*TOLEDO CITY
PLAN COMMISSION
REPORT*

April 10, 2014

| 1. SPR-11-14 & MRO-2-14: | Major Site Plan Review for Middlegrounds Metropark at 111 Ottawa Street (tg) |

SITE PLAN

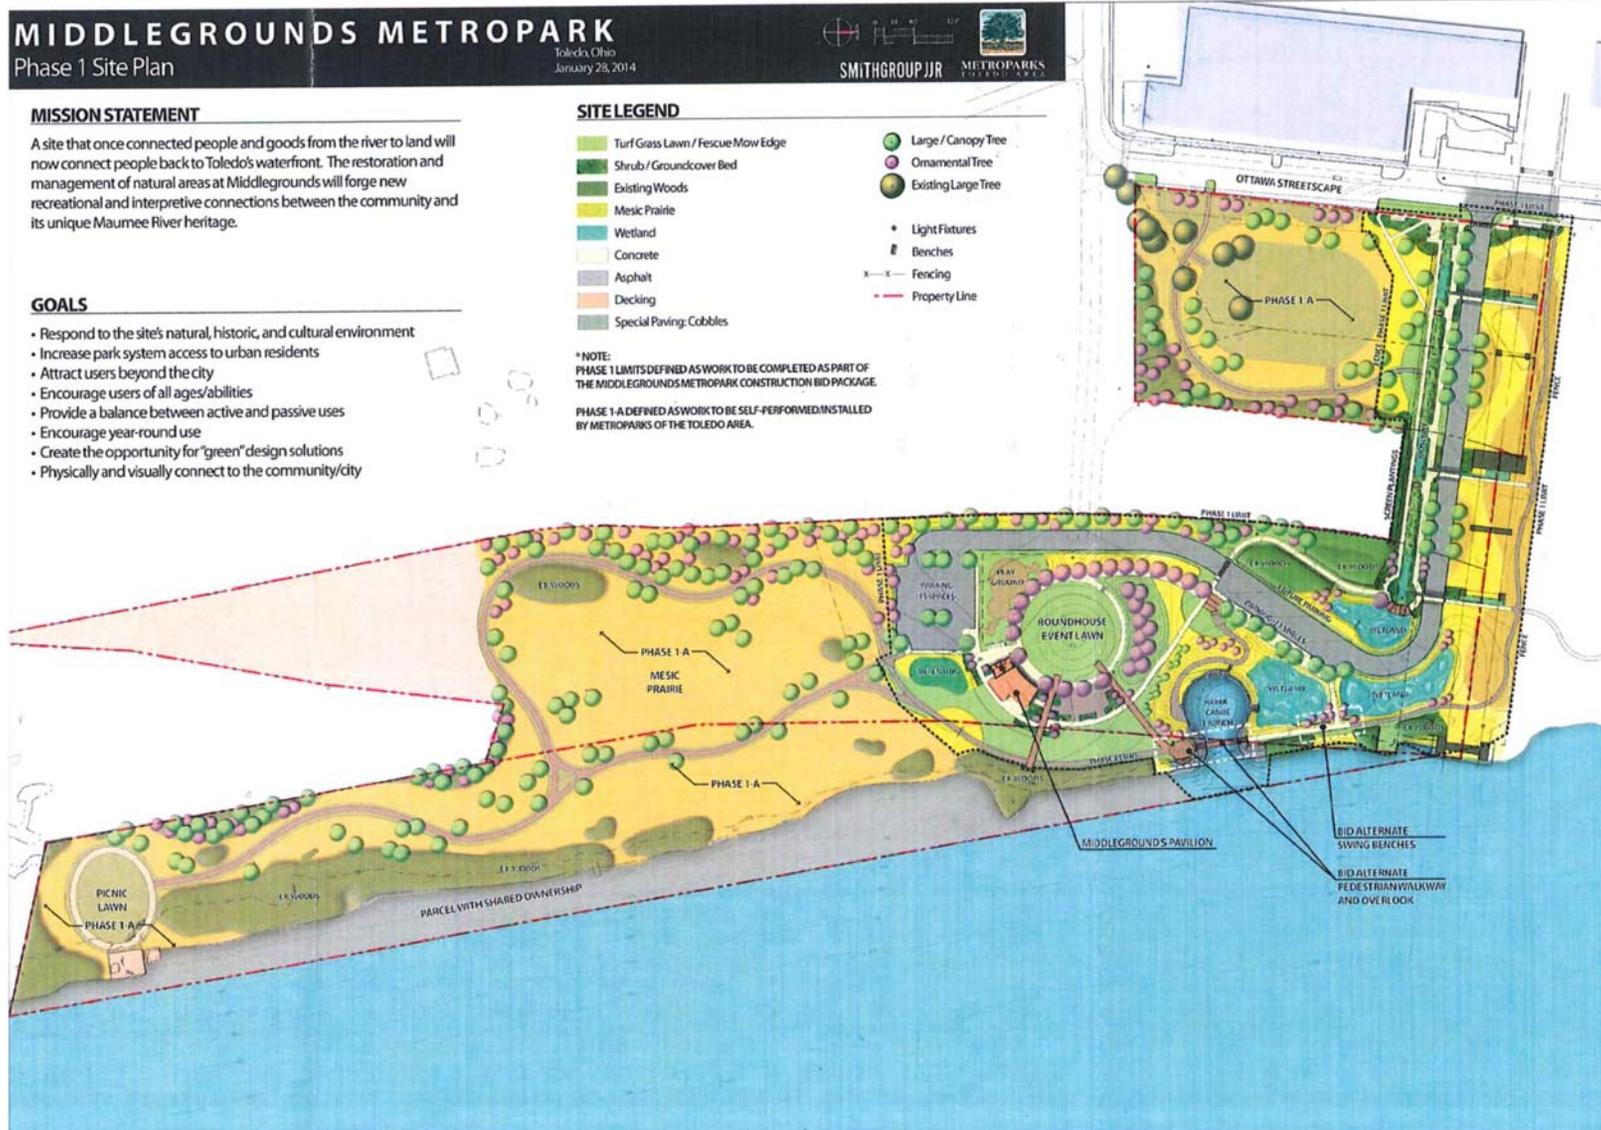
The site plan indicates 66 parking spaces are allocated for the park, which is based on a needs assessment of parking spaces for this type of facility. The parking lots are located west of the kayak and canoe launch and south of the Roundhouse event lawn. The applicant is proposing to install a drive that will commence at Ottawa Street and traverse the northern portion of the park to access the parking lot on the south side of the park.

Pedestrian walking trails are clearly indicated on the plan and will circulate throughout the park. The trail will eventually connect to the Owens Corning trail to the north, which will help in connecting the park to the downtown waterfront.

A detailed landscape plan indicates that sufficient landscaping will be installed throughout the park utilizing appropriate species for this type of development. Wetland areas will be introduced to handle storm water from the Anthony Wayne Bridge and on site. This will be enhanced with native plants. Improved river front forested habitat and upland mesic grassland habitat will be introduced as well. The plan indicates adequate perimeter landscaping on all property lines.

20. A 36" combined sewer is shown on the plans crossing through the property. This sewer has been separated and is now a storm sewer only.
21. For maintenance purposes, an easement for the storm sewer is required. No permanent structures shall be constructed over the storm sewer.
22. Sanitary sewer service for this development is available subject to the Rules and Regulations of the Department of Public Utilities.
23. A single sanitary sewer tap from this site shall be allowed into the public sanitary sewer system. Developer shall use existing sanitary tap, when available.

SITE PLAN

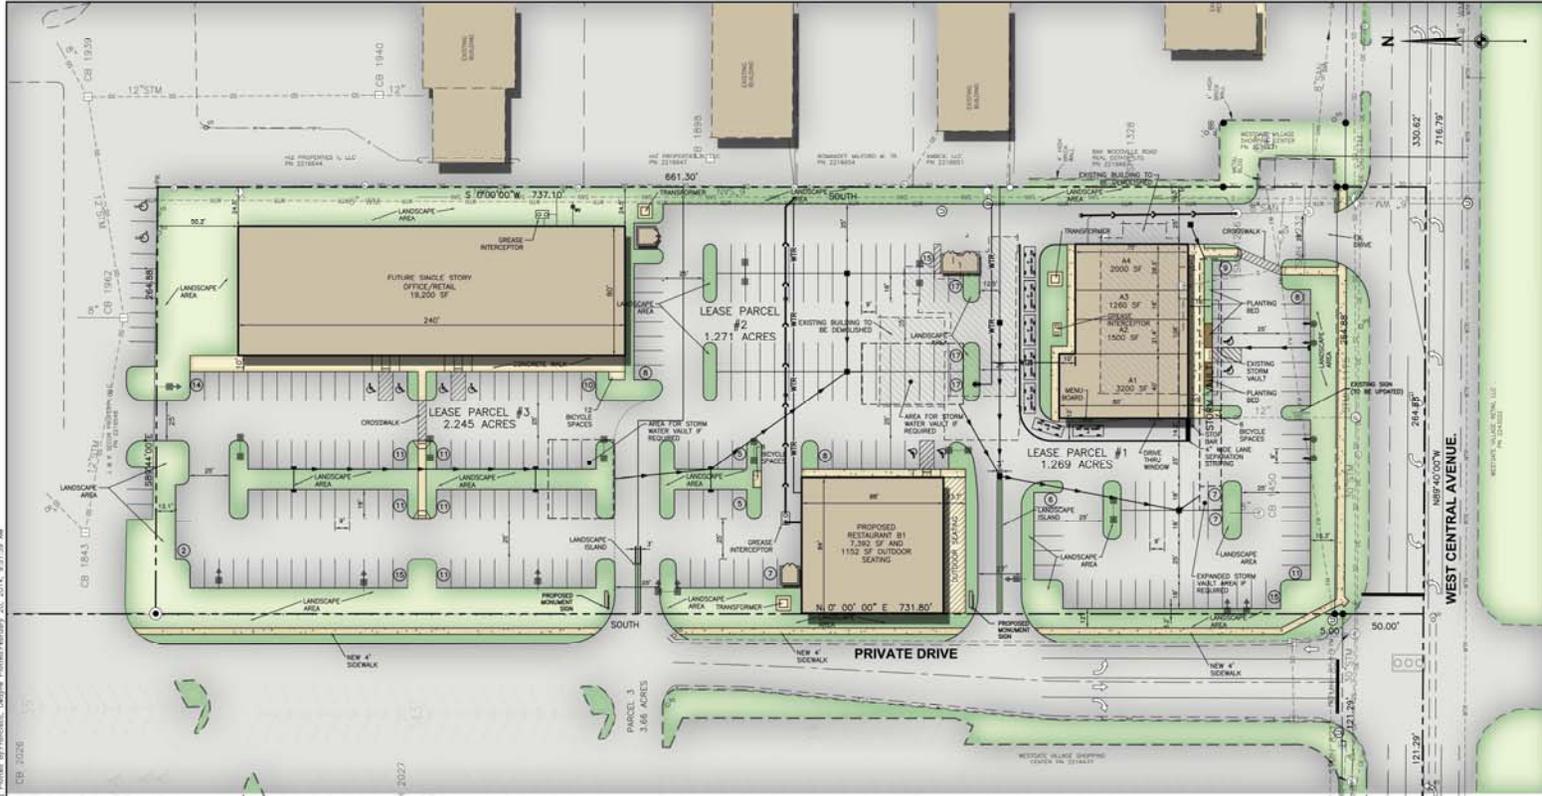
The site plan indicates 412 parking spaces allocated for the entire development, which is 58 spaces over the required 354 parking spaces. The parking spaces will be distributed in parking fields on each of the building sites. The applicant is proposing to use the existing private drive north of Central as an entrance to the proposed parking lots.

Pedestrian connections are clearly indicated on the plan. Sidewalks are proposed along Central Avenue and the private drive. An additional pedestrian connection shall be installed for the largest building on the north portion of the site. The proposed sidewalk and crosswalk should be extended from the landscape area located in front of the main entrance to the sidewalk along the private drive.

The site plan indicates that the dumpsters for the building closest to Central Avenue are located behind the structure in the parking lot near the east property line. This dumpster needs to be relocated to accommodate interior landscaping. The dumpster for proposed building closest to the entrance drive is located on the north side of the building behind a transformer. With proper landscaping and screening this should not be visible from public view. The dumpster for the building in the rear of the site is located on the south side of the building adjacent to the east property line, (it is not within public view).

SITE PLAN

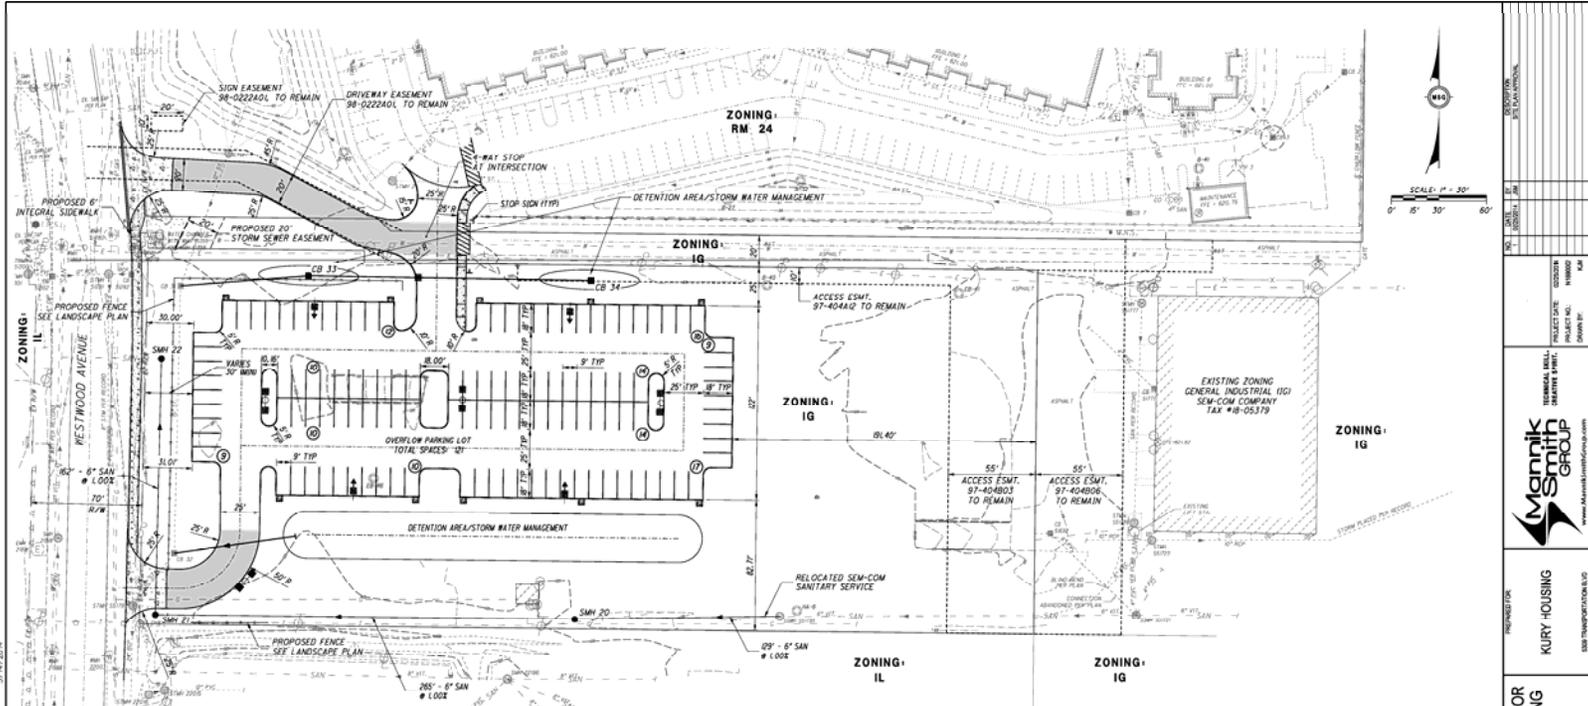
- d. All landscaped areas must have a minimum dimension of at least 9 feet and be at least 160 square feet in area. A landscape island shall be installed in the parking lot directly south of the northern curb cut; **shall be depicted on revised landscape plan.**

- k. If site is ½ acre or larger, landscaped areas must be irrigated as necessary to maintain required plant materials in good and healthy condition. Irrigation plans must be submitted with development plans and must contain all construction details; **shall be noted on revised landscape plan.**

- l. The location, height and materials of any fencing to be installed and maintained; **shall be noted on revised landscape plan.**
- m. The location, type and direction of any proposed lighting. The lighting is subject to the approval of the Director of the City of Toledo Plan Commission (lights are to be directed away from adjacent residential properties); **acceptable as depicted on landscape plan.**

SITE PLAN

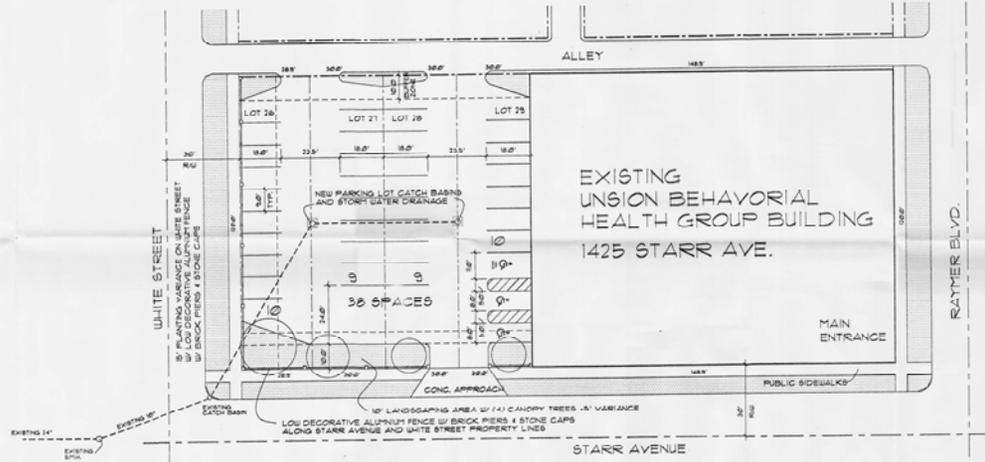
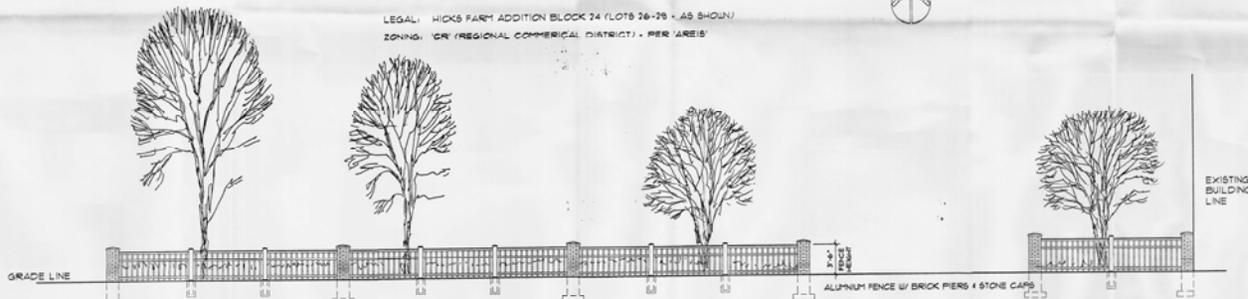
- Waiver of TMC§1108.0202 - *Frontage Greenbelt*, along Starr Avenue from fifteen (15) feet to ten (10) feet. This will provide additional room for vehicular maneuverability throughout the site. A decorative fence with brick and stone accents will be provided along with four (4) trees. A solid hedge will be required to be located on the outside of the fence. **Staff recommends approval of the waiver request subject to the addition of a solid hedge located on the outside of the decorative fence.**

- Waiver of TMC§1108.0203 - *Buffer and Screening Requirements – Type A Buffer*. The applicant is requesting relief on the ten (10) foot requirement with fence required for a Type A buffer. The applicant is proposing to add five (5) foot to seven (7) foot wide landscaping islands at the entrance points of the parking lot, however, no plantings are indicated on these islands. With the addition of one (1) tree per 30 linear feet of frontage and a continuous shrub on each island, **Staff recommends approval of the waiver request.**

The Division of Transportation has objected to the proposed site plan. The plan does not meet the minimum standards set forth in the Toledo Municipal Code. The Division of Transportation has specifically objected to the drive aisle width being less than twenty-five (25) feet and curb cuts onto the alley being used as a means of ingress and egress.
